SUBJECT: ISSUANCE OF TECHNICAL SPECIFICATION AMENDMENTS FOR THE BROWNS FERRY
NUCLEAR PLANT UNITS 1, 2, AND 3 (TAC NOS. M89251, M89252, AND
M89253) (TS 339)

The Commission has issued the enclosed Amendment Nos. 216, 232, and 190 to Facility Operating Licenses Nos. DPR-33, DPR-52, and DPR-68 for the Browns Ferry Nuclear Plant (BFN), Units 1, 2, and 3, respectively. These amendments are in response to your application dated March 31, 1994 regarding extended load line limit and revised rod block monitor operability requirements, deletion of specific values for rated reactor recirculation flow rate, relocation of rod block equations to the core operating limits report, and other miscellaneous changes.

AMENDMENT TO FACILITY OPERATING LICENSE

Amendment No. 216
License No. DPR-33

Figure 2.1-1

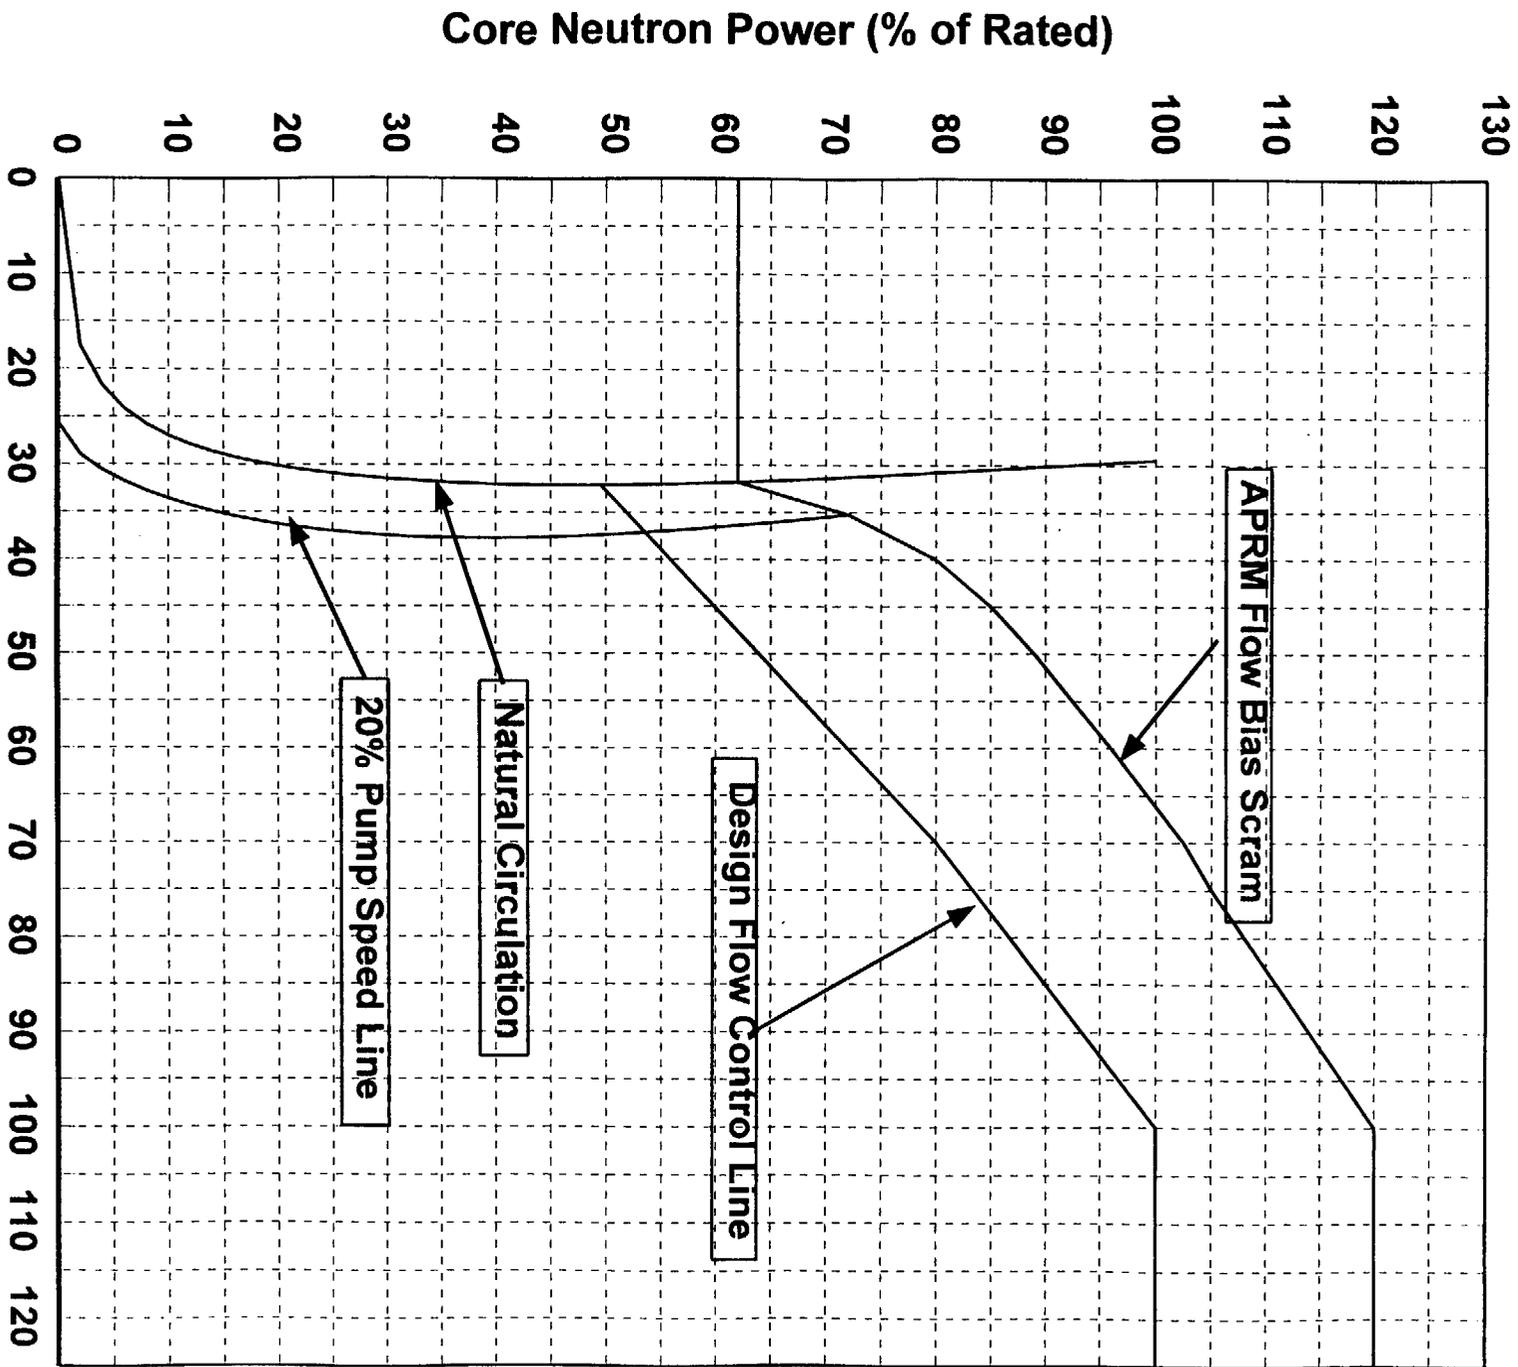
DELETED

Figure 2.1-1

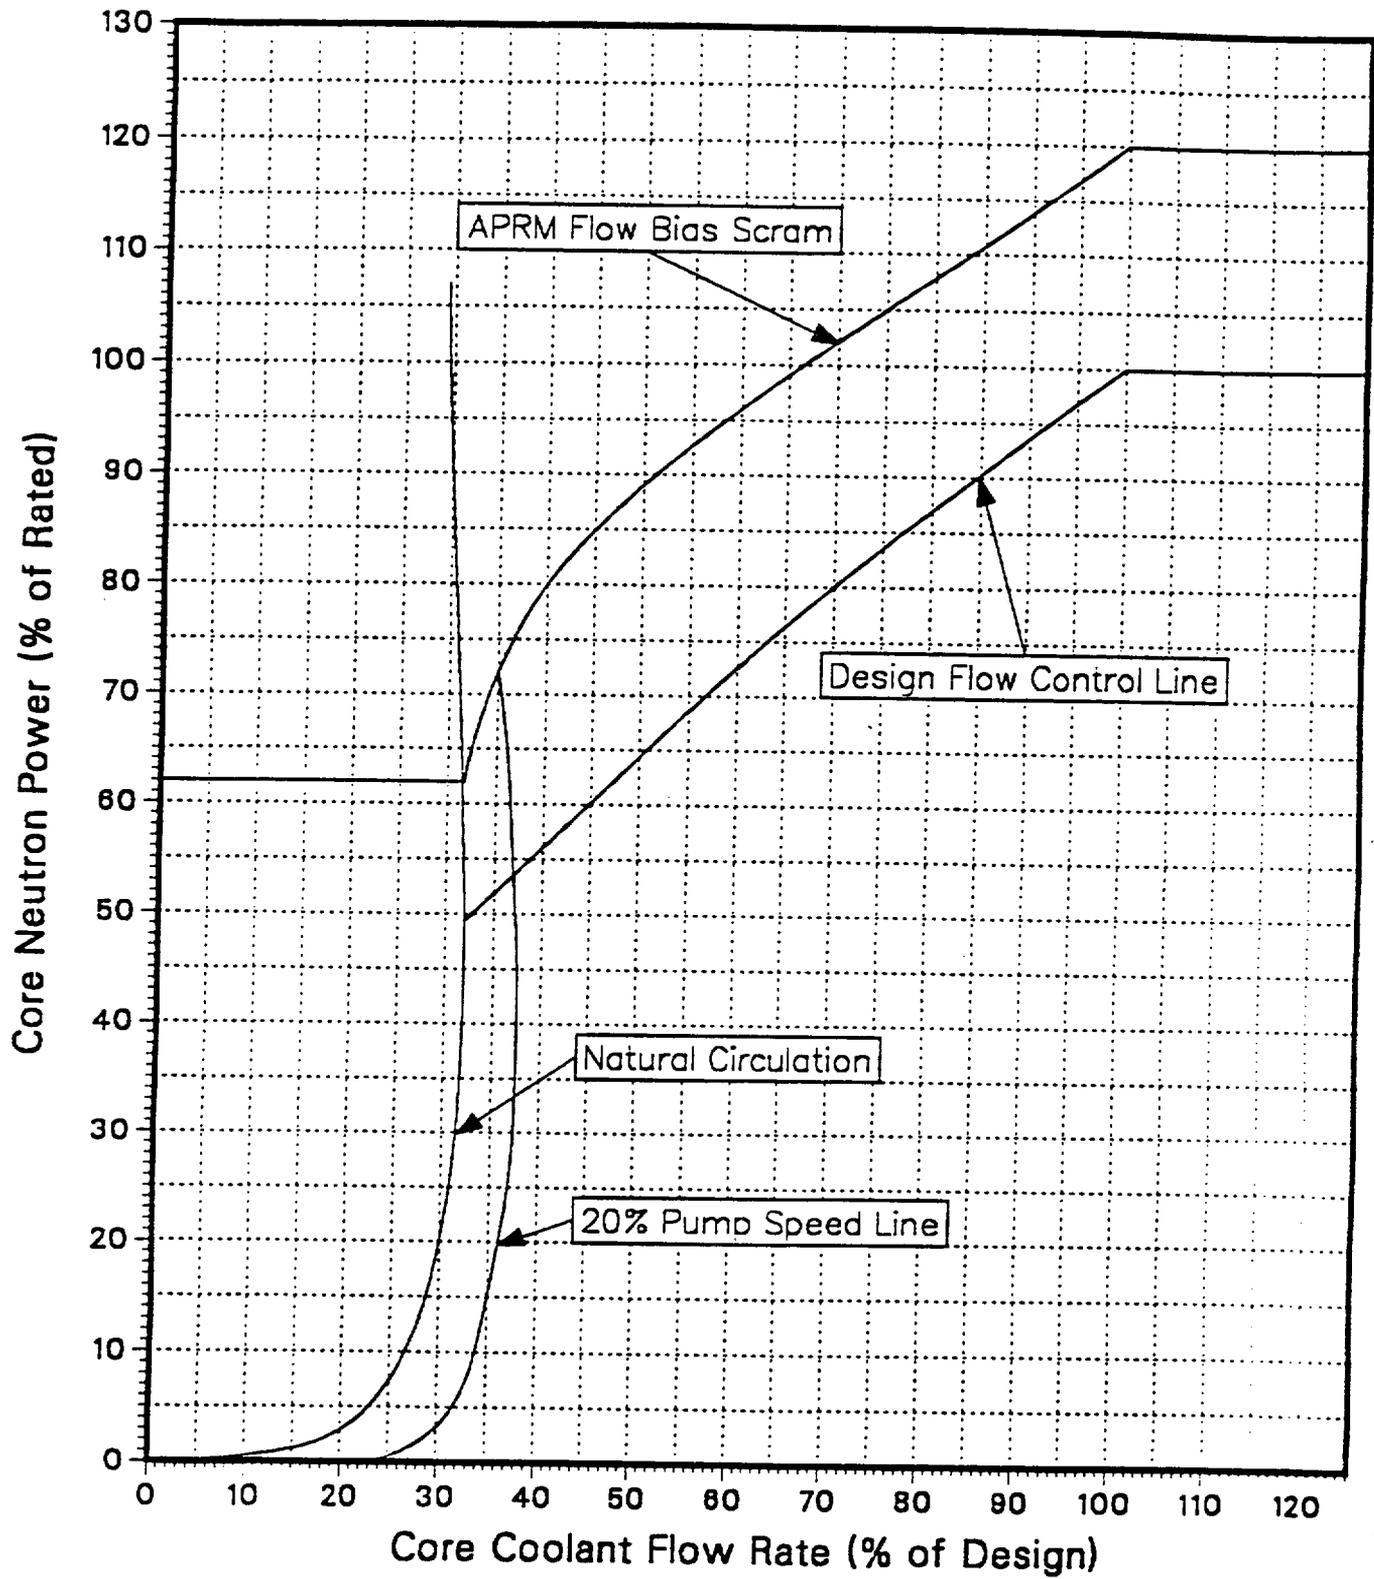
DELETED

Figure 2.1-1

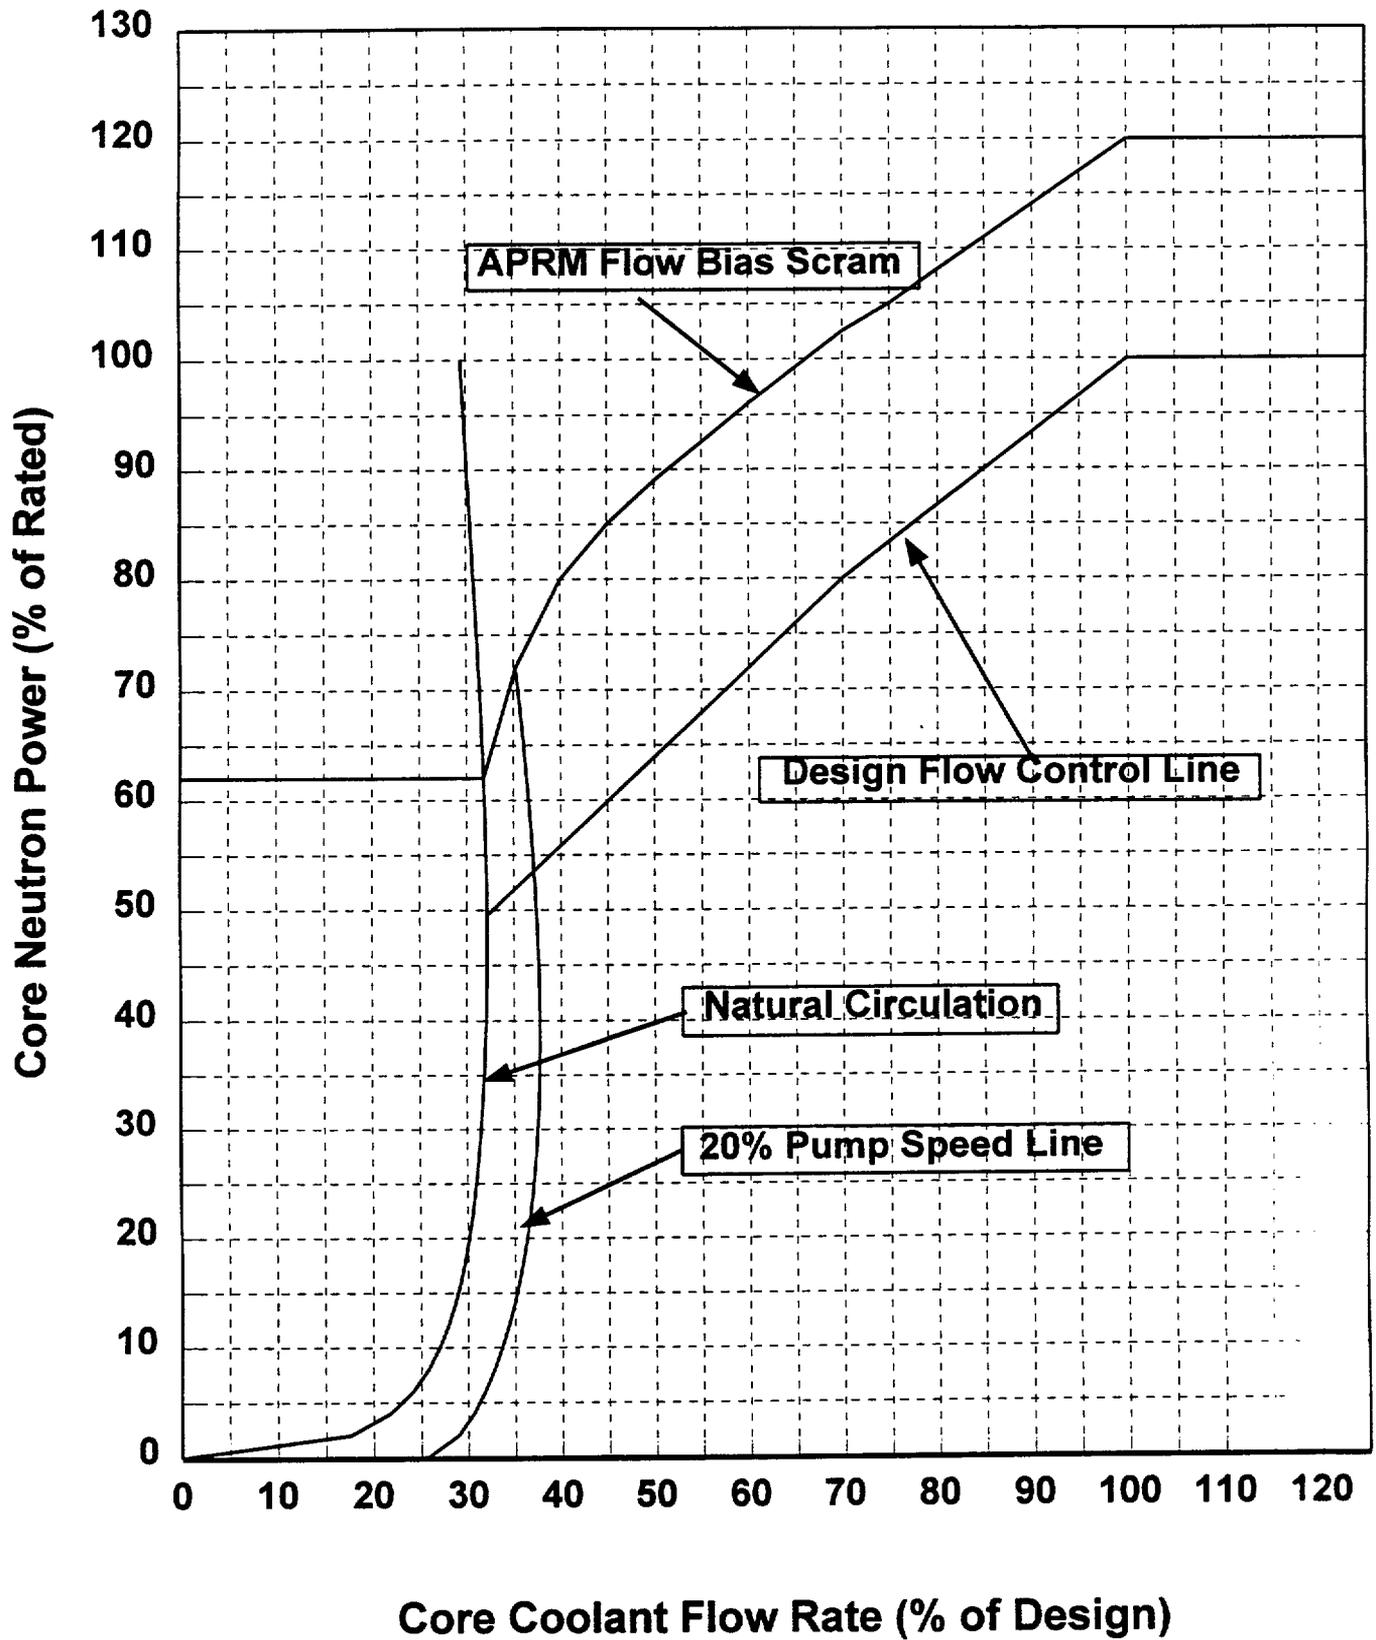
DELETED
